Project	IEEE 802.16 Broadband Wireless Access Working Group < <a href="http://ieee802.org/16">http://ieee802.org/16</a> >	
Title	In-band Non-transparent Relay Frame Structure	
Date Submitted	2006-03-14	
Source(s)	<p>Kanchei (Ken) Loa, Yi-Hsueh Tsai, Yung-Ting Lee, Chih-Chiang Hsieh, Shiann-Tsong Sheu, Hua-Chiang Yin, Frank C.D. Tsai, Youn-Tai Lee, Heng-Iang Hsu  Institute for Information Industry  8F., No. 218, Sec. 2, Dunhua S. Rd., Taipei City, Taiwan.</p> <p>Hang Zhang, Peiying Zhu, Mo-Han Fong, Wen Tong, David Steer, Gamini Senarath, Derek Yu, Mark Naden, G.Q. Wang  Nortel  3500 Carling Avenue  Ottawa, Ontario K2H 8E9</p> <p>Gang Shen, Kaibin Zhang  Alcatel-Lucent, Research &amp; Innovation  388#, Ningqiao Road, Shanghai, China.</p> <p>[add co-authors here]</p>	<p>Voice: +886-2-2739-9616  <a href="mailto:loa@iii.org.tw">loa@iii.org.tw</a></p> <p>Voice: +1 613 7631315  <a href="mailto:WenTong@nortel.com">WenTong@nortel.com</a>  <a href="mailto:pyzhu@nortel.com">pyzhu@nortel.com</a></p> <p>Voice: 86-21-58541240-8194  <a href="mailto:gang.a.shen@alcatel-sbell.com.cn">gang.a.shen@alcatel-sbell.com.cn</a></p>

# In-band Non-transparent Relay Frame Structure

Figure yyy—Example of minimum configuration for an in-band non-transparent relay frame structure

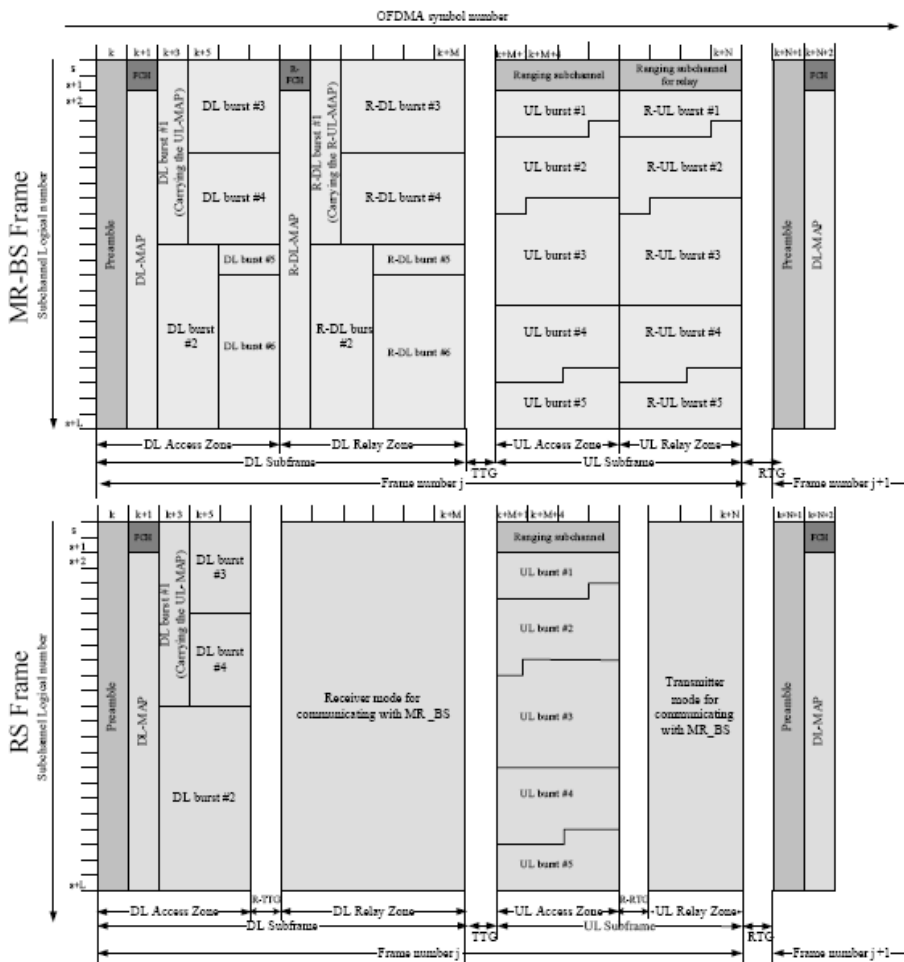
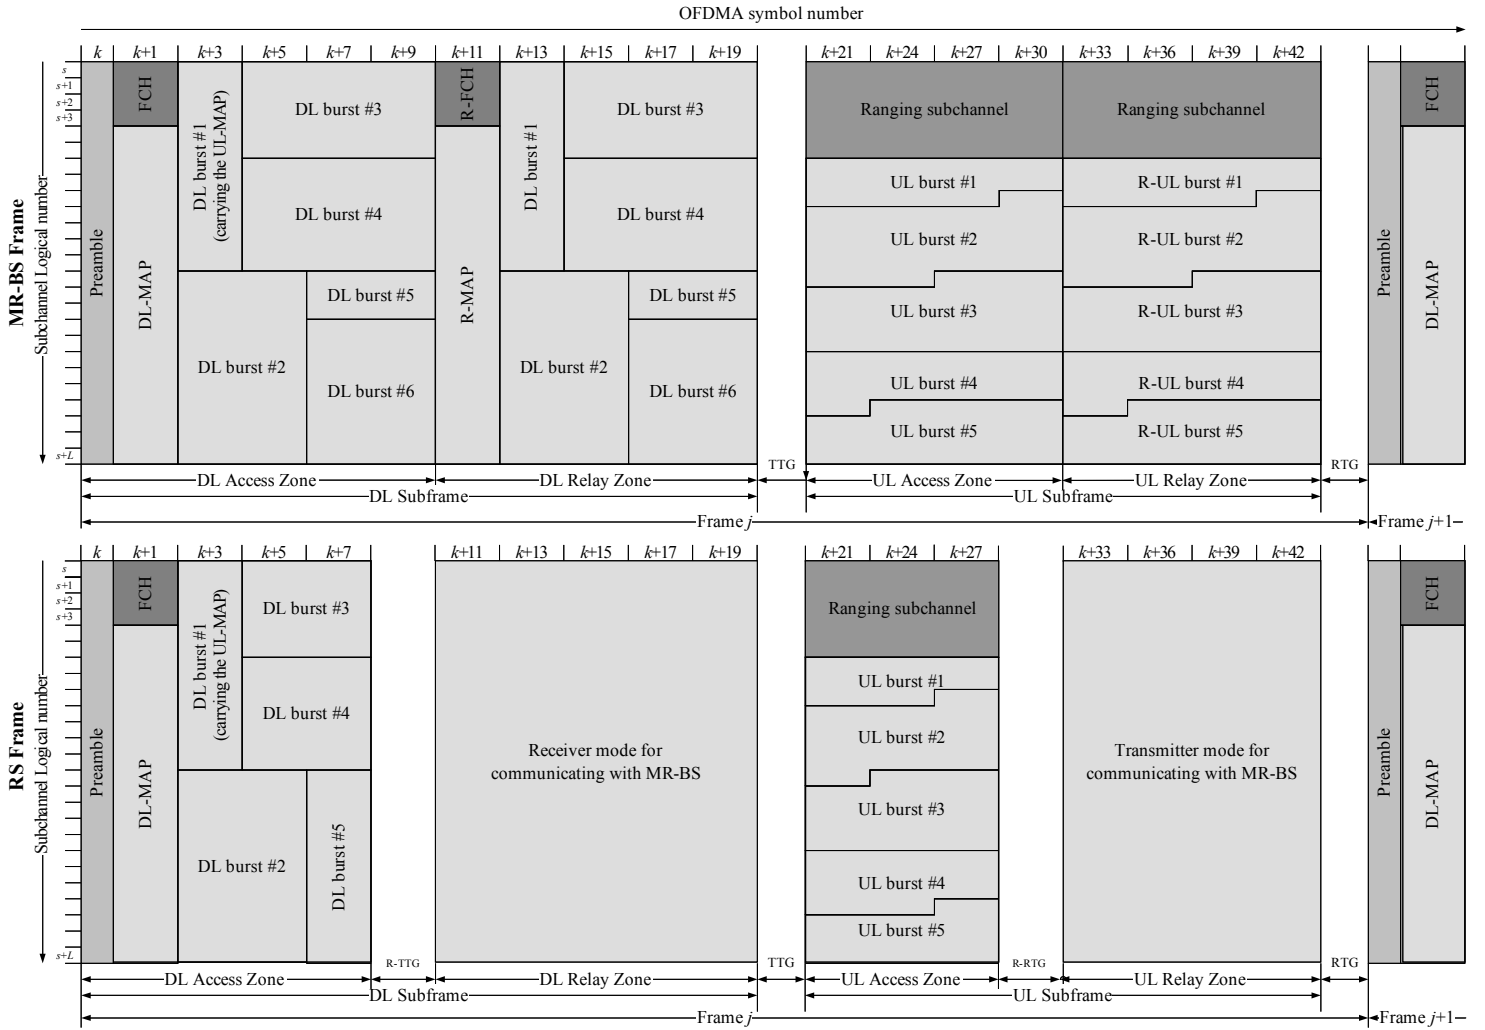
[Change the figure in section 8.4.4.7.2 “Frame structure for non-transparent mode” as indicated:]

[Replace Figure xxx with Figure yyy as follows:]
